J. F. DAVIDSON-CIVIL ENGINEER
 E. NO. 862
 RIVERSIDE, CALIFORNIA
 APPROVED BY *J. F. Davidson* DATE 4-5-60
 CITY OF RIVERSIDE, CALIF.
 DEPARTMENT OF PUBLIC WORKS

SEWER PLAN & PROFILE
RUMSEY DRIVE
 RS 3/12

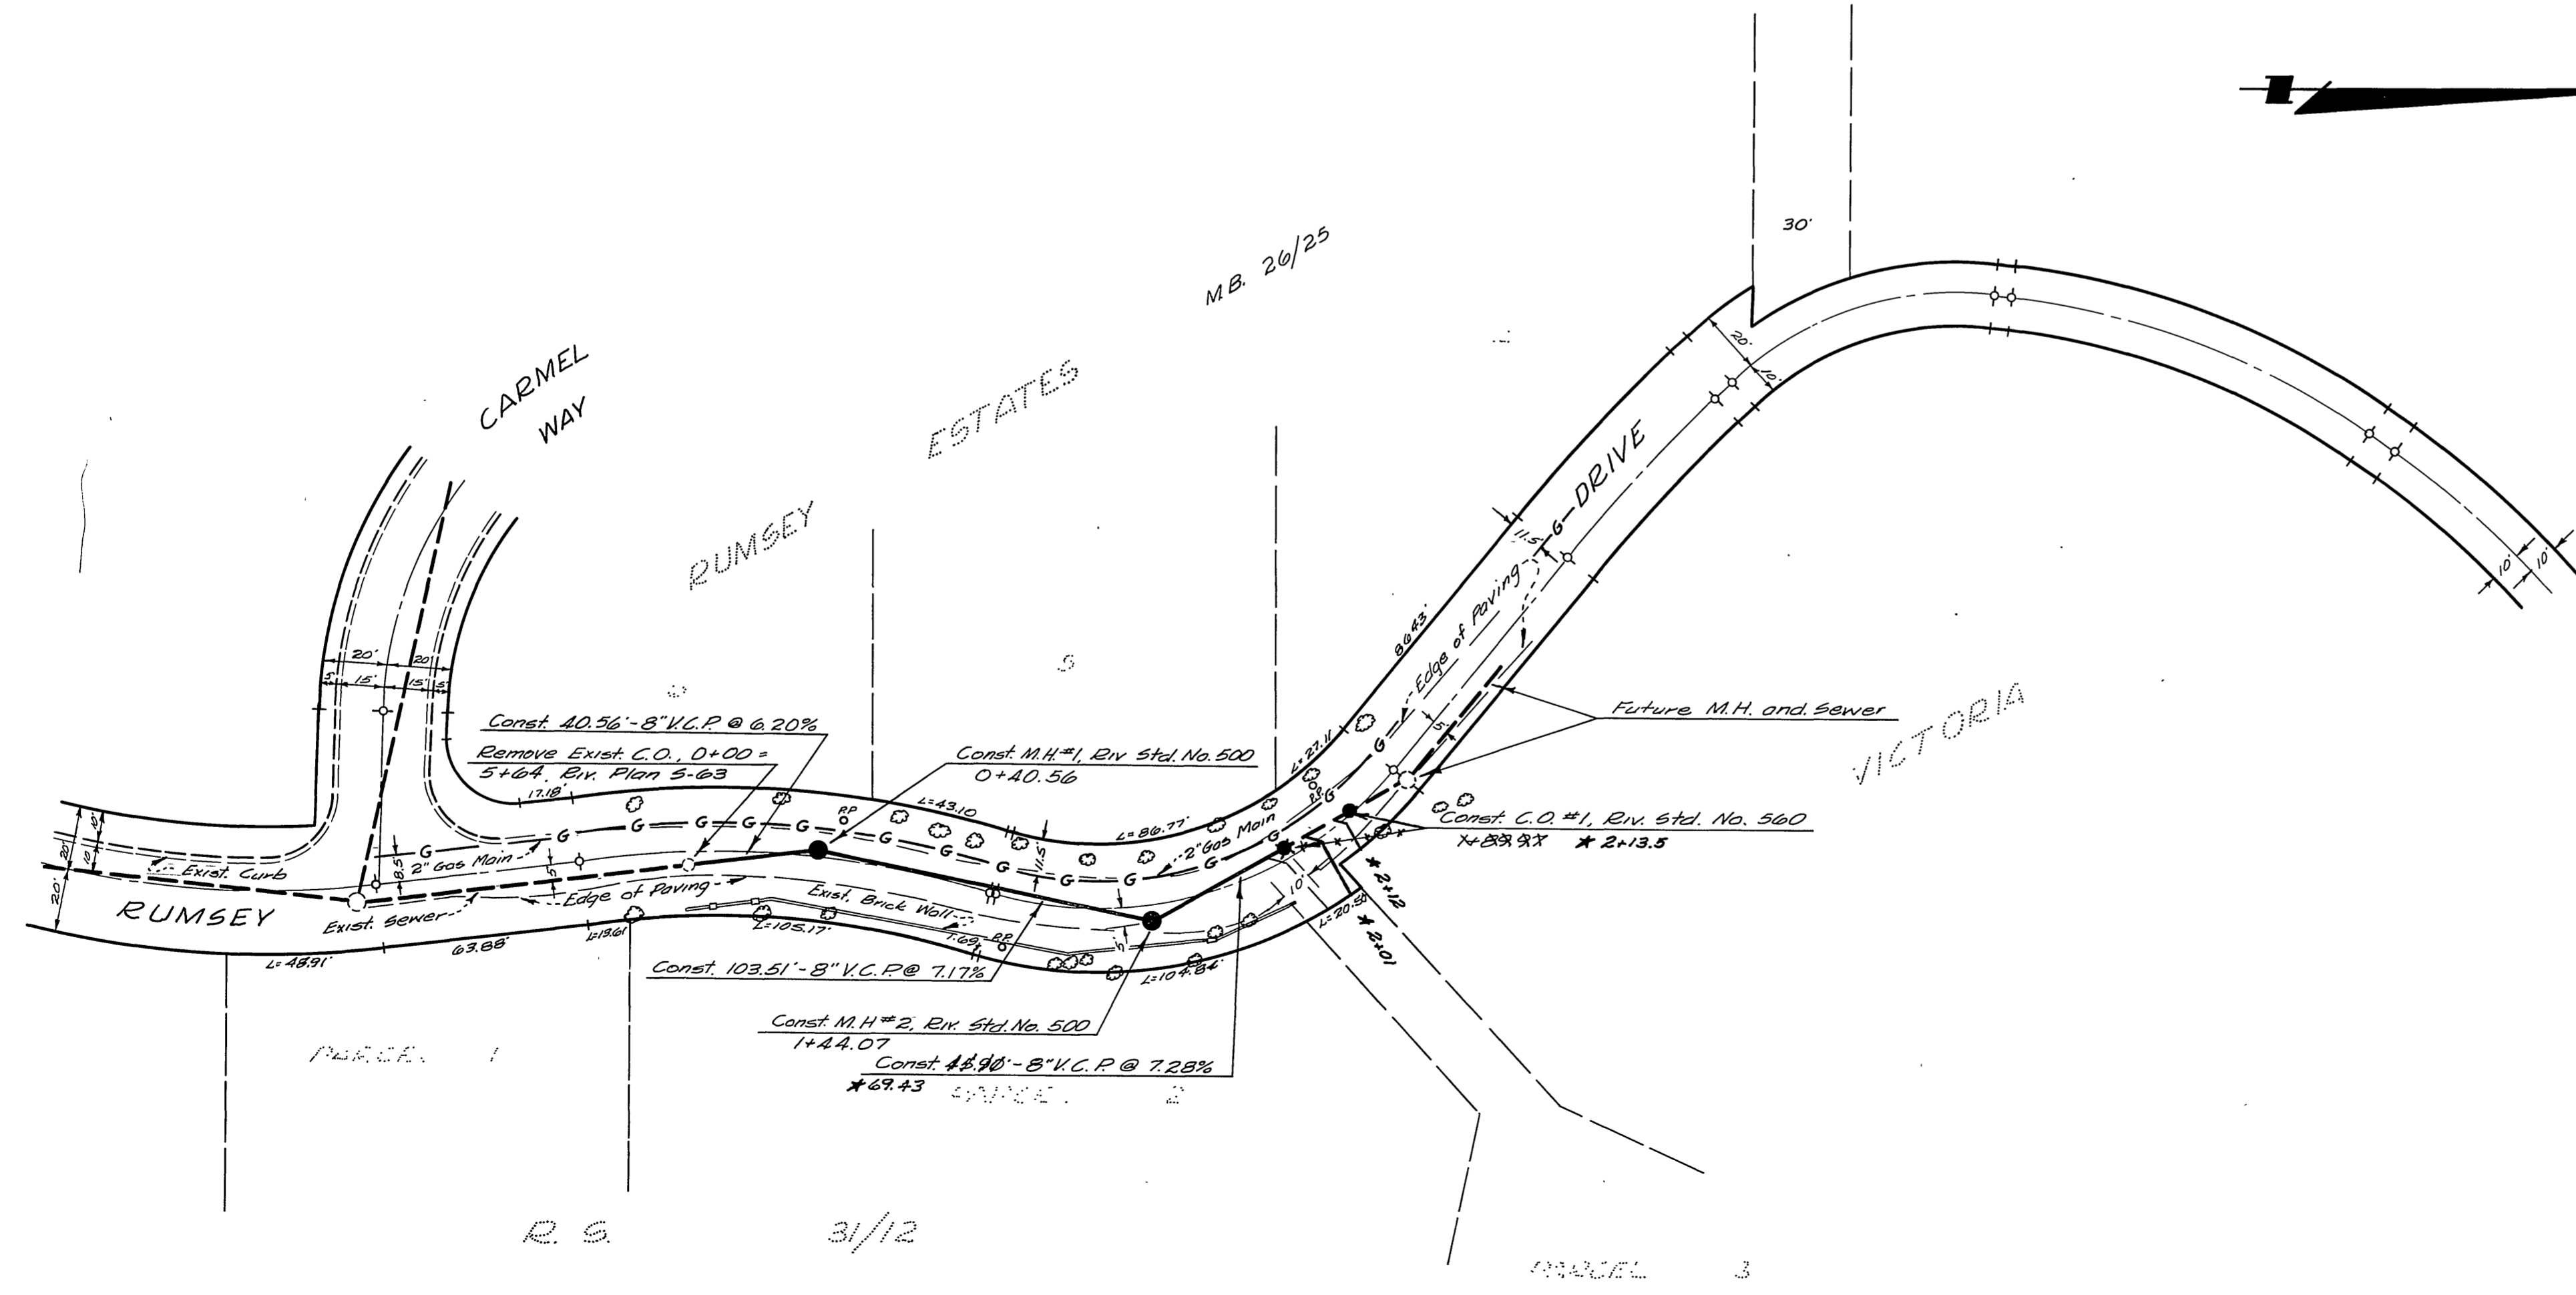
REVISION
 Raised sewer grade from M.H. #1 to C.O. #1, May 10, 1960
 Approved by *A.R. Schul* For Director of Public Works
 Date May 10, 1960
